Access Compliance Report

Public Rights-of-Way

Intersection ID: 3415	Main Street: WHITEWOOD_TL	Cross Street: POPLAR_GROVE_DR	Location: SE
ADA ID: F02A92168EAF	Ramp Type: Perp	Initial Pass/Fail: Fail	Overall Compliance: No
		Severity Score: 15

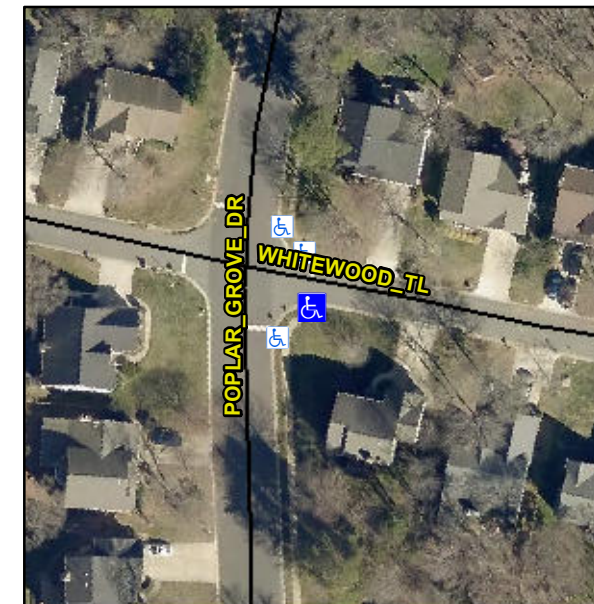
Not Found, R302.7

N/A	Ramp inside XWalk1?	N/A	N/A	Ramp inside XWalk2?	N/A
	Road Slope (%)	N/A	N/A	Clear Space?	N/A
	Road X Slope (%)	N/A	N/A	Clear Space to XWalk (in)	N/A
N/A	Any Obstructions?	N/A	N/A	Storm Grate/Utility Hazard?	N/A
	Obstruction Type			Storm Grate/Utility Type	
		N/A			N/A
		No		Surface Condition? (G/P)	Poor

Remove & Replace Entire Ramp.
